# ADDENDUM NO. 4

May 5, 2022

# YOST ELEMENTARY SCHOOL ADDITIONS AND RENOVATIONS Chesterton, IN 46304

This Addendum consists of Pages ADD 4-1 and attached Addendum No. 4 from Gibraltar Design dated May 4, 2022 and consisting of 5 pages and 24 drawings.

© GIBRALTAR DESIGN SHEET C-11

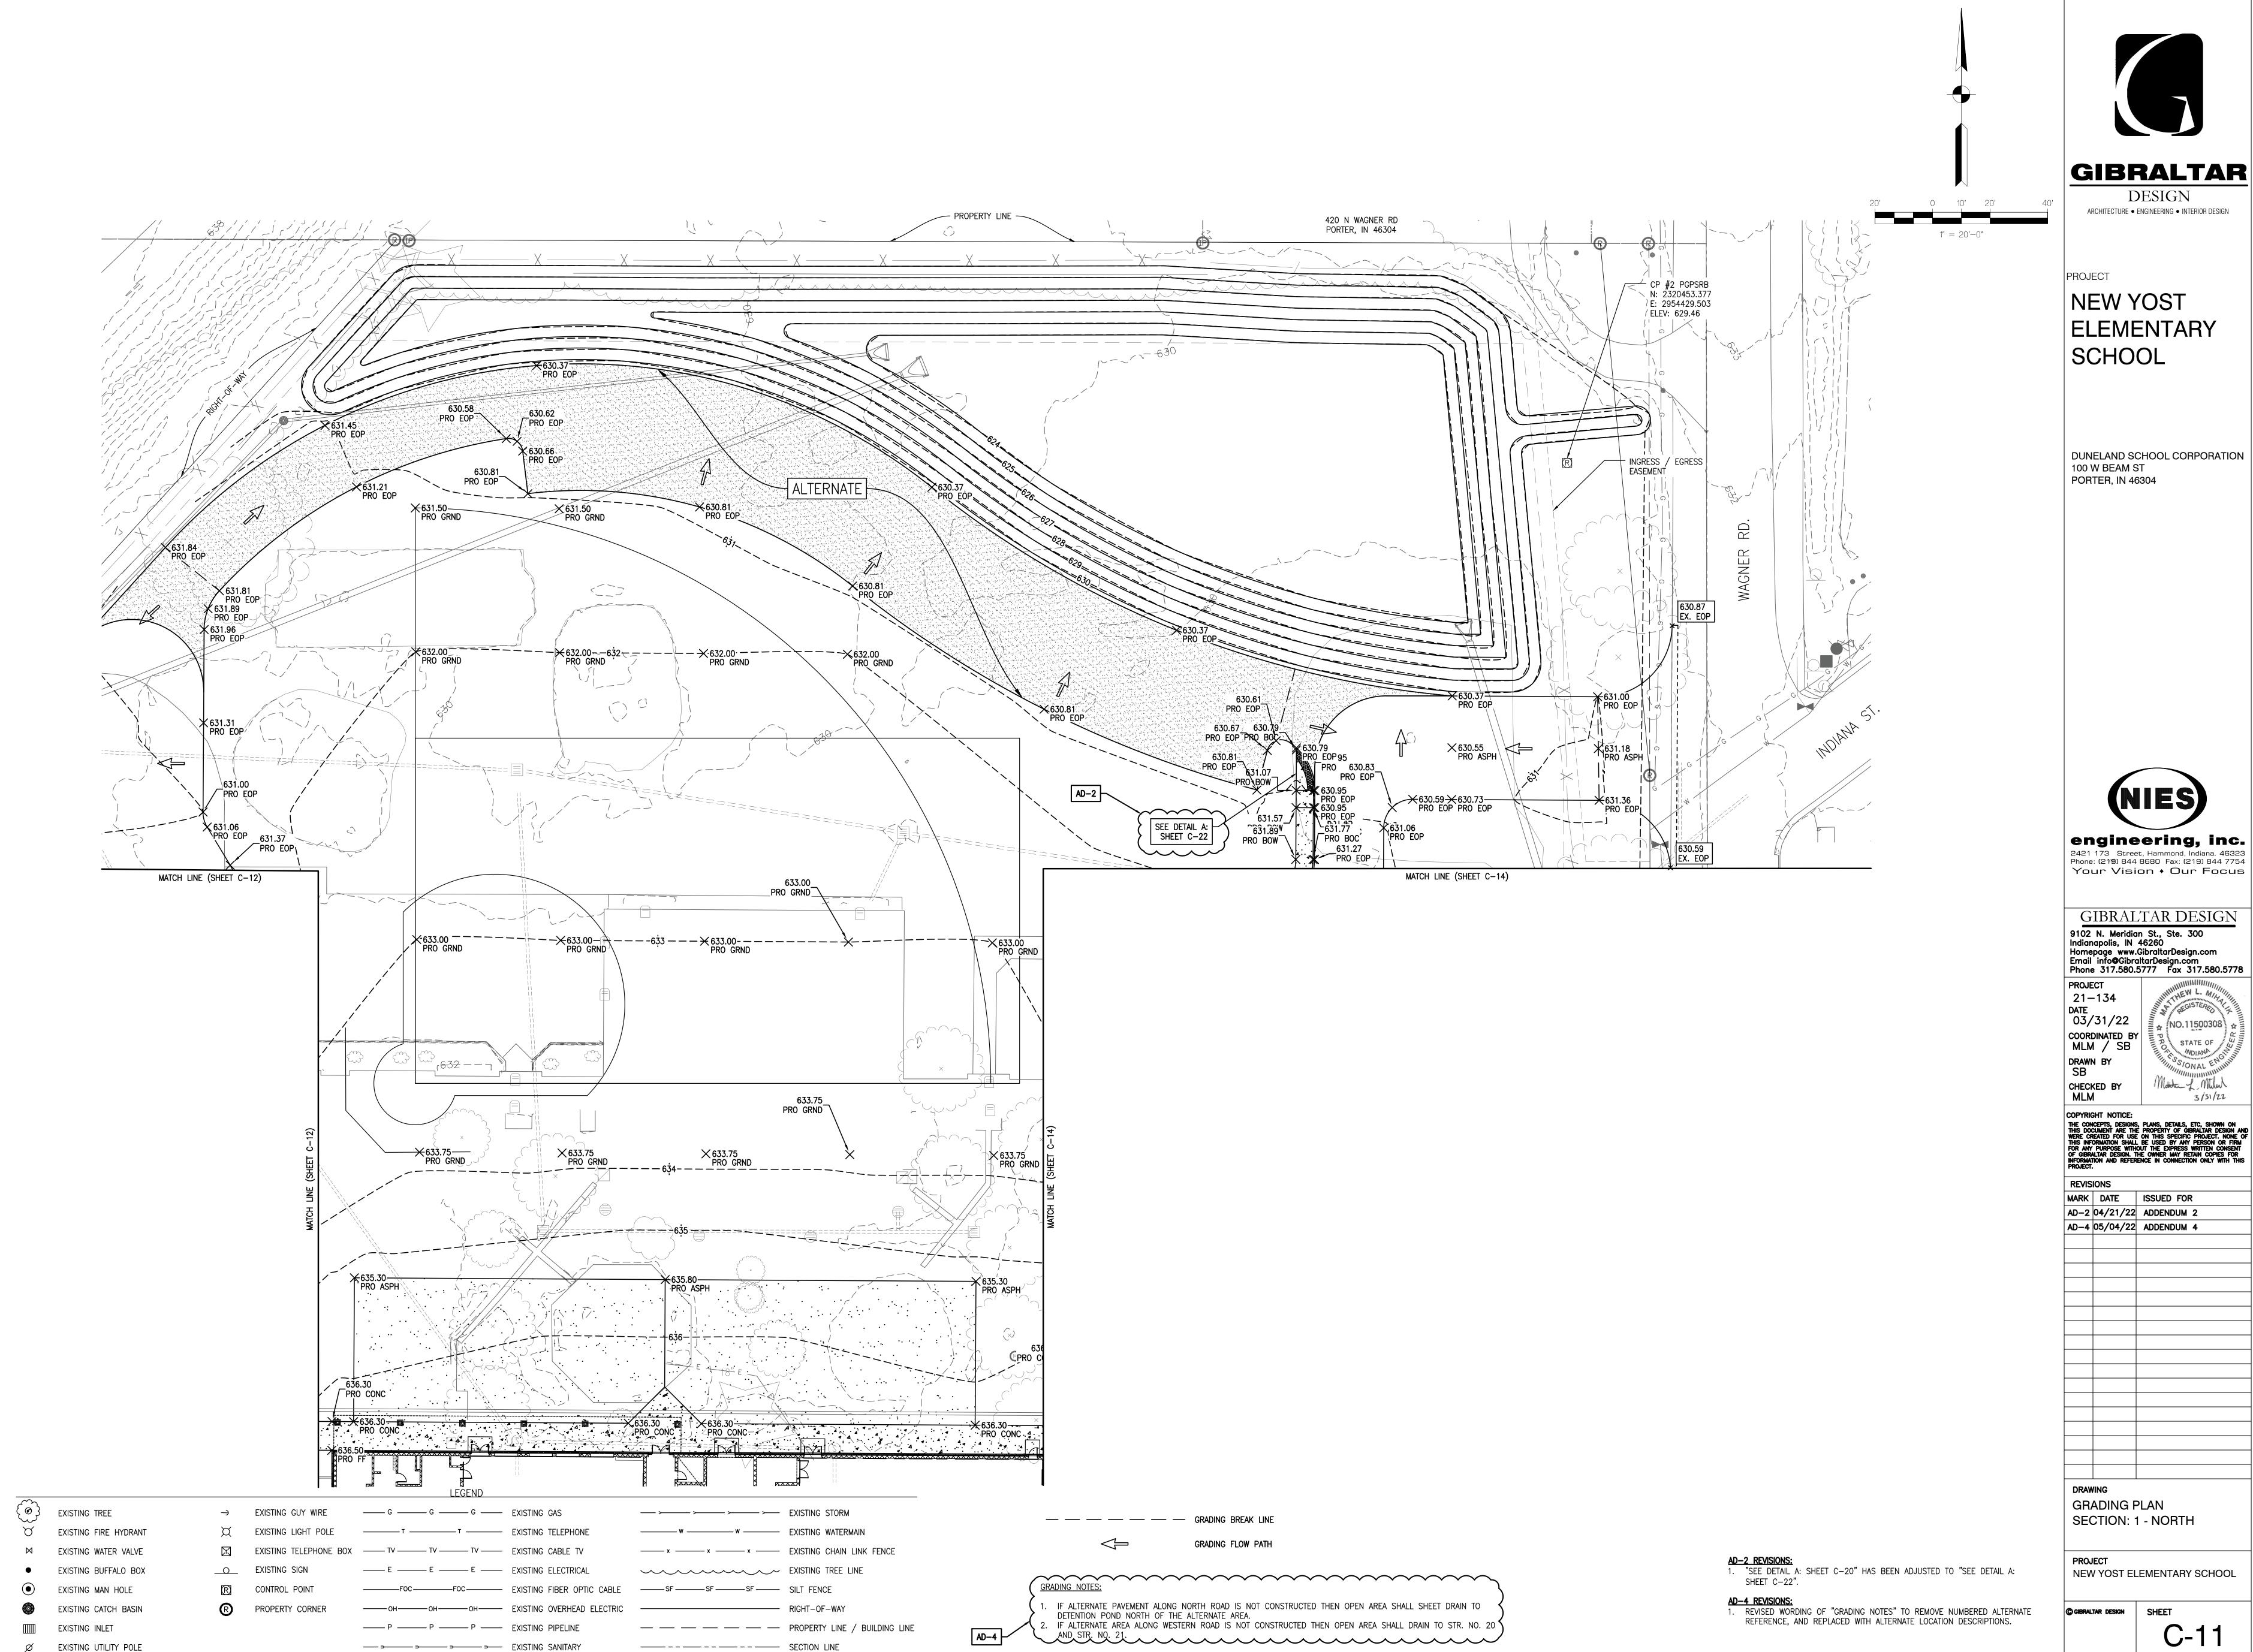
- A. Refer to two (2) revised full size drawings, included in this Addendum, for the following revisions:
  - 1. Revised wording of "Grading Notes" to removed numbered alternate reference and replaced with alternate location descriptions.

**DRAWING GRADING PLAN** SECTION: 2 - WEST

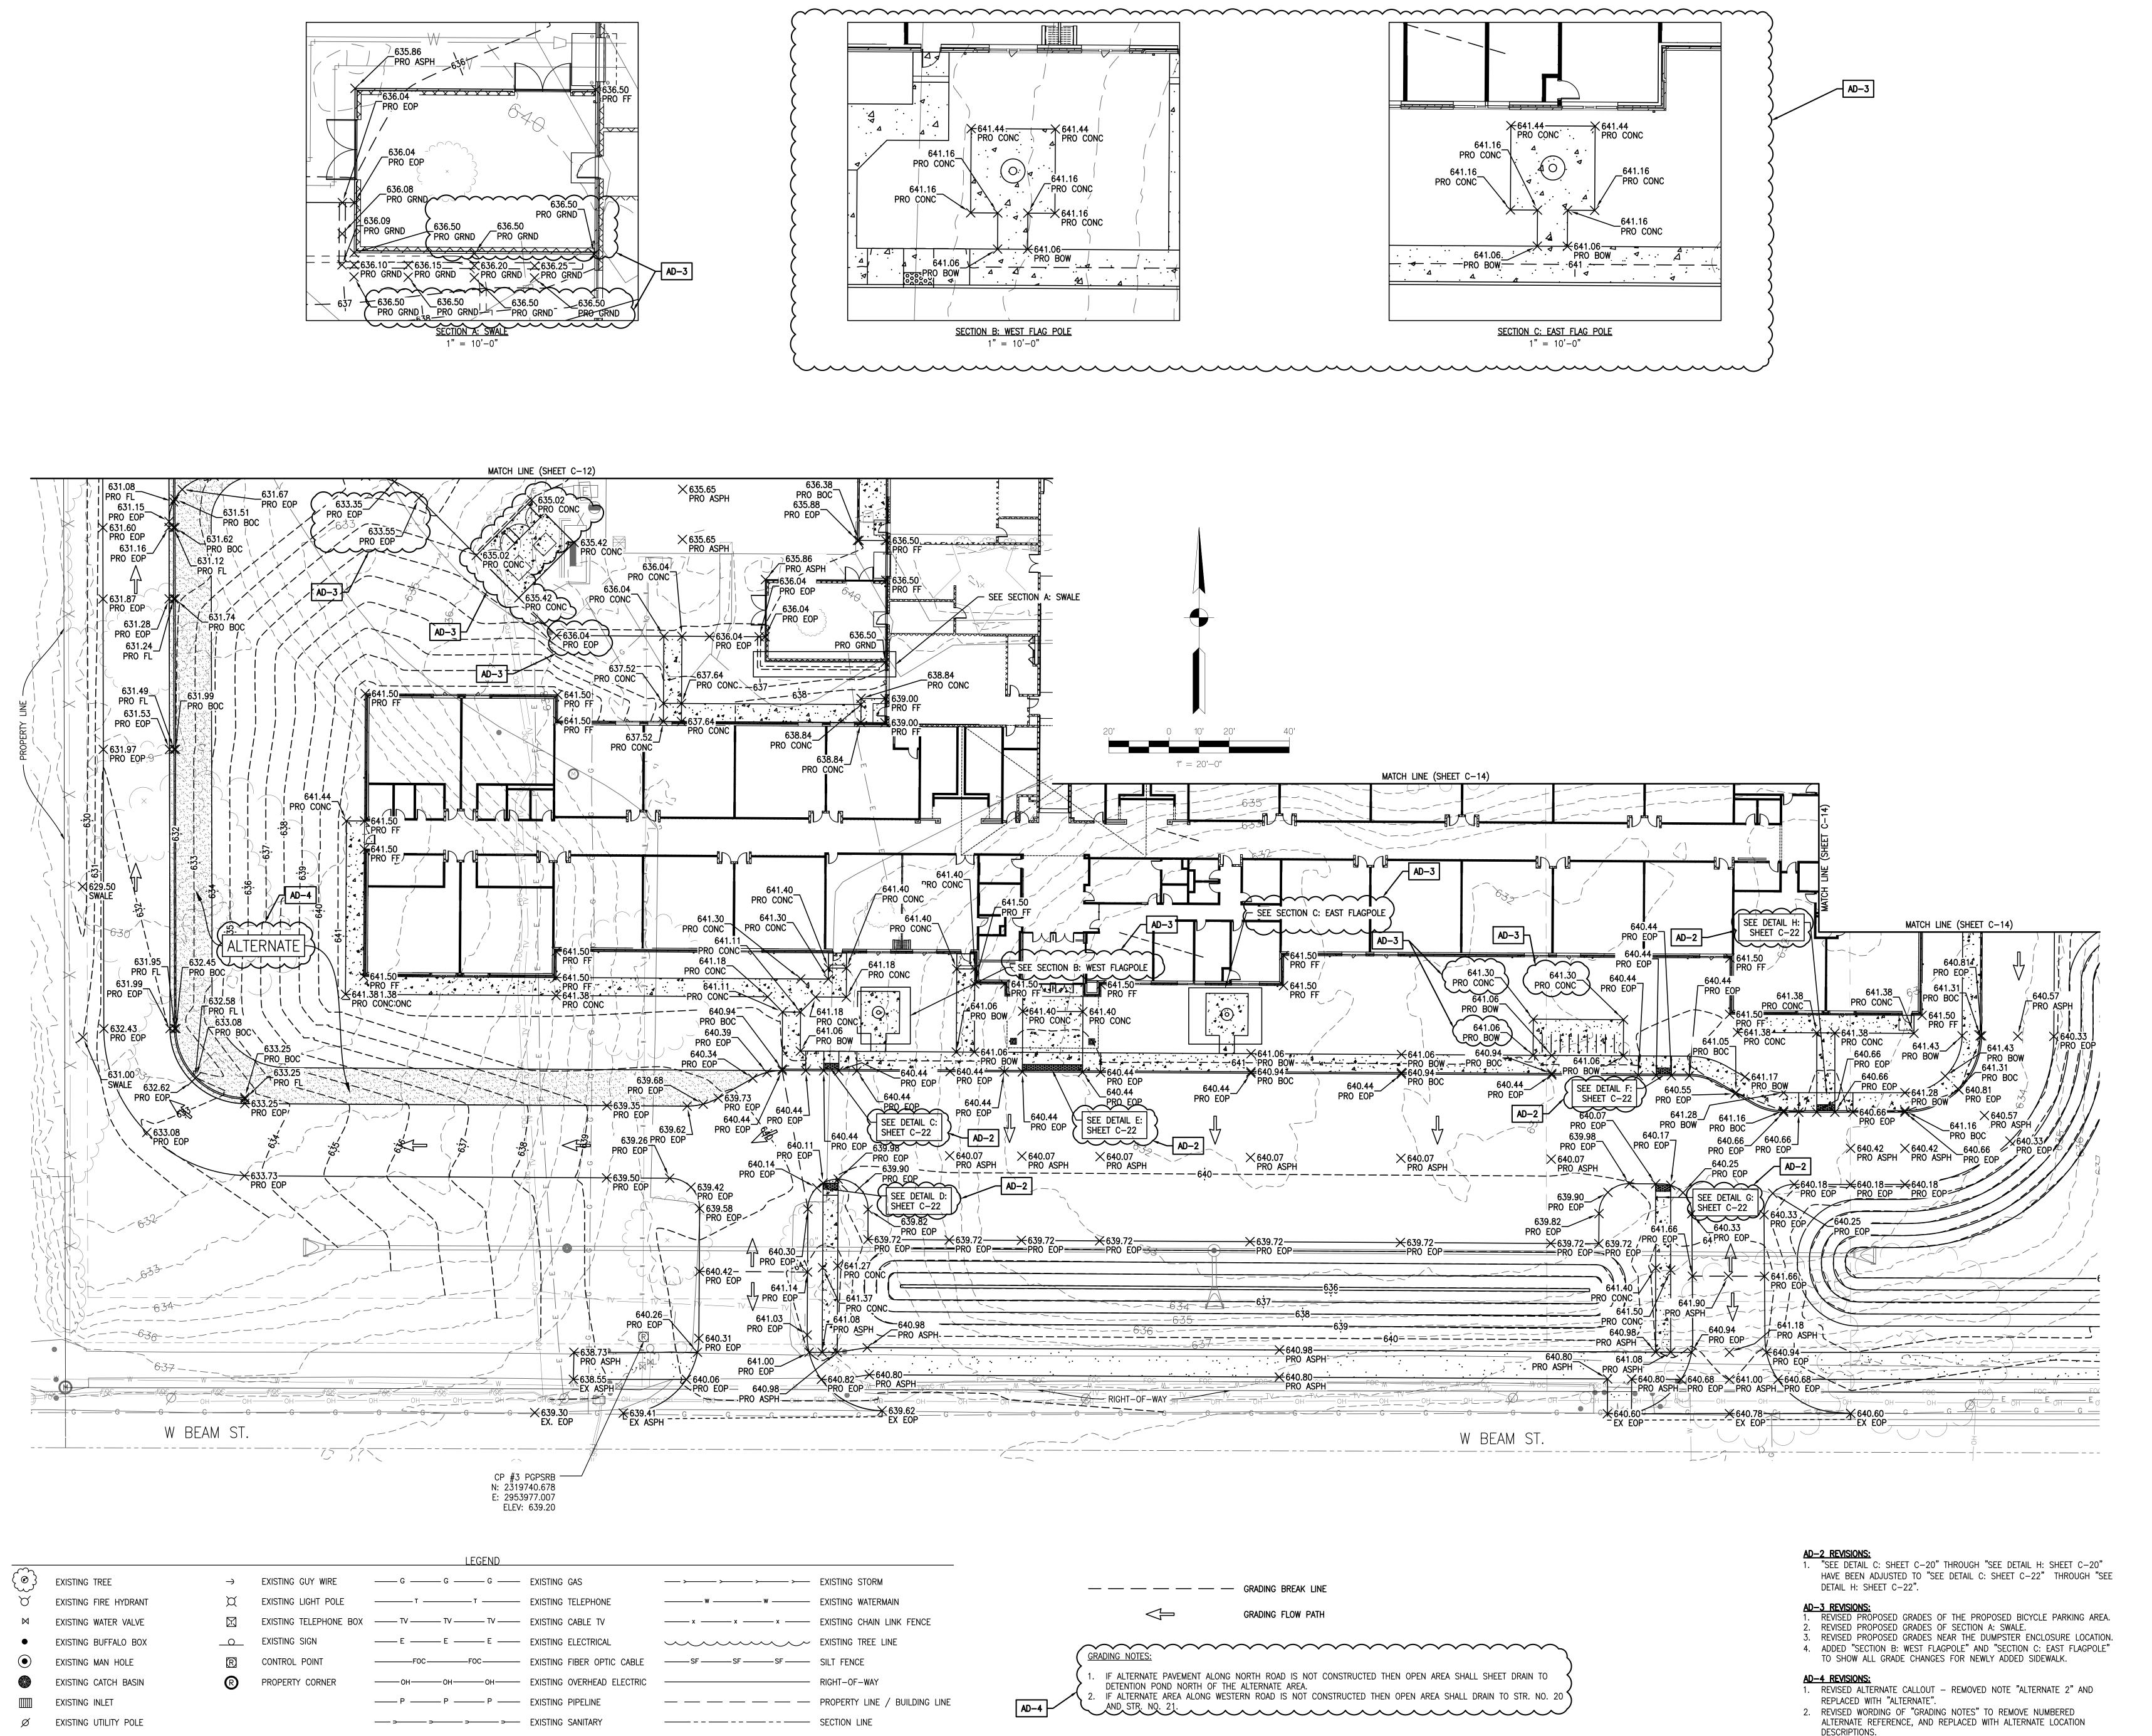
1. REVISED ALTERNATE CALLOUT — REMOVED NOTE "ALTERNATE 2" AND

REPLACED WITH "ALTERNATE". 2. REVISED WORDING OF "GRADING NOTES" TO REMOVE NUMBERED ALTERNATE REFERENCE, AND REPLACED WITH ALTERNATE LOCATION DESCRIPTIONS.

© GIBRALTAR DESIGN SHEET A-103

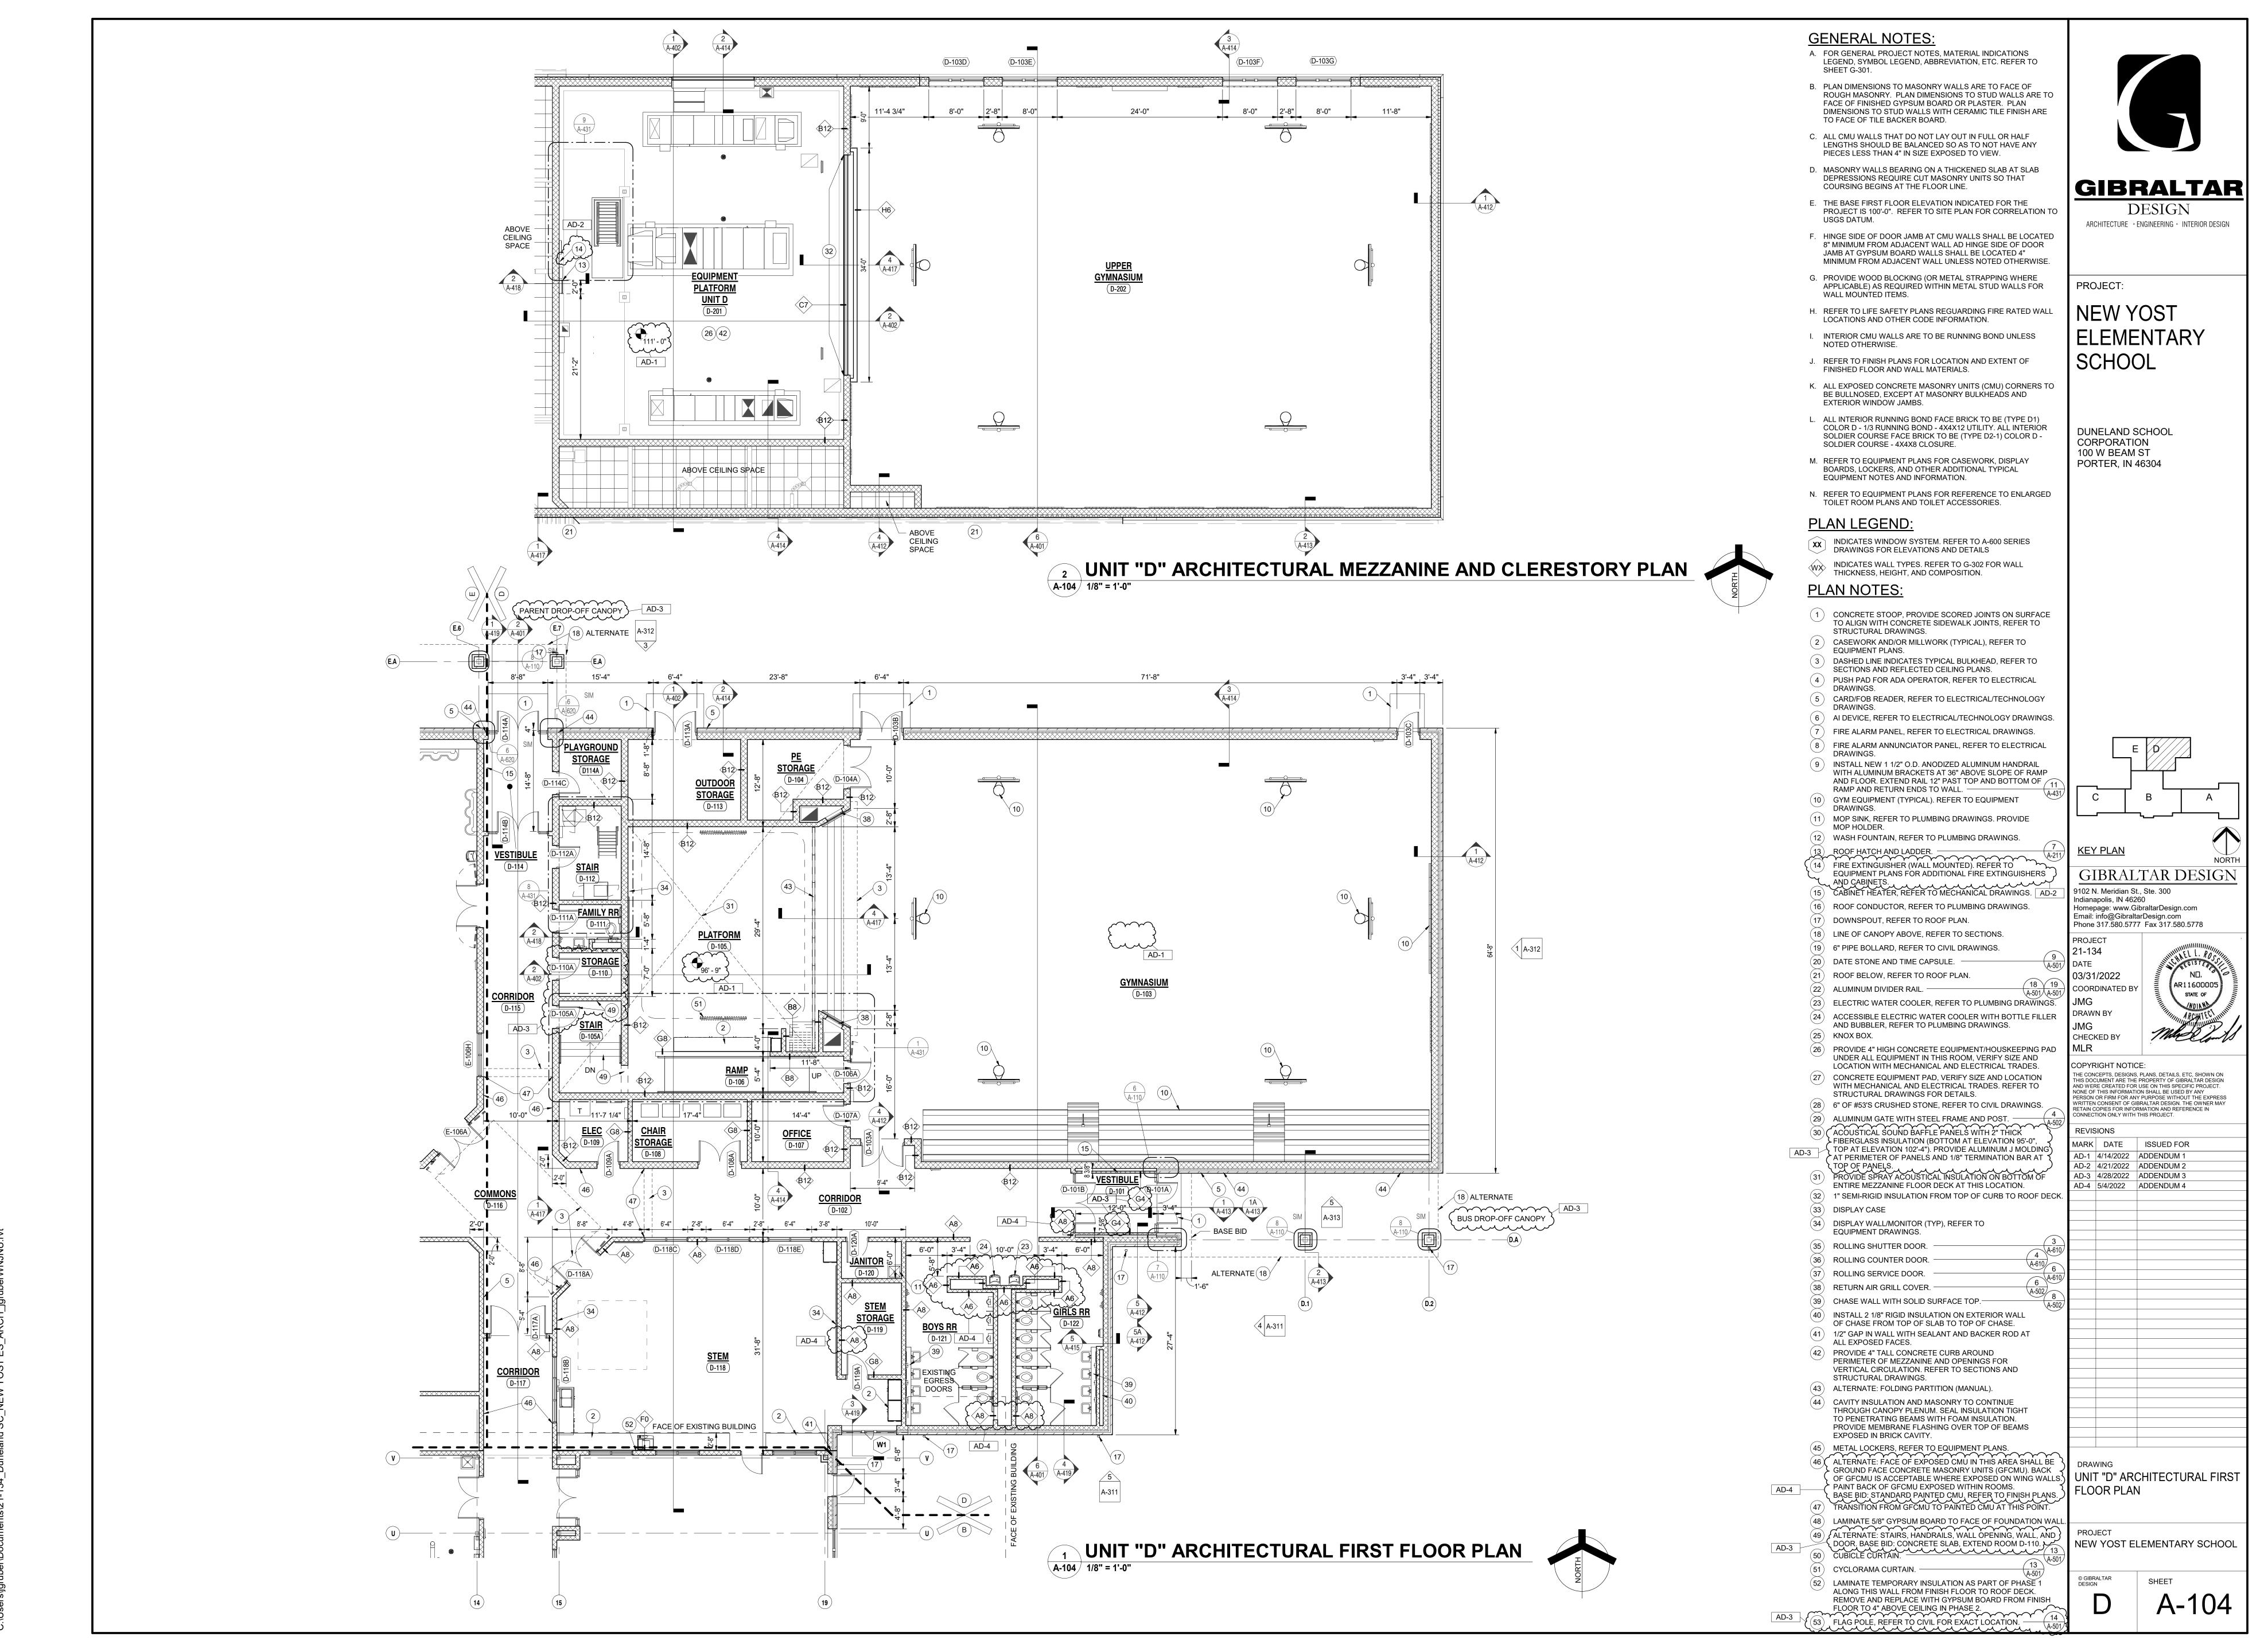
A. Refer to three (3) revised full size drawings, included in this Addendum, for clarification of partition types at classroom entries.
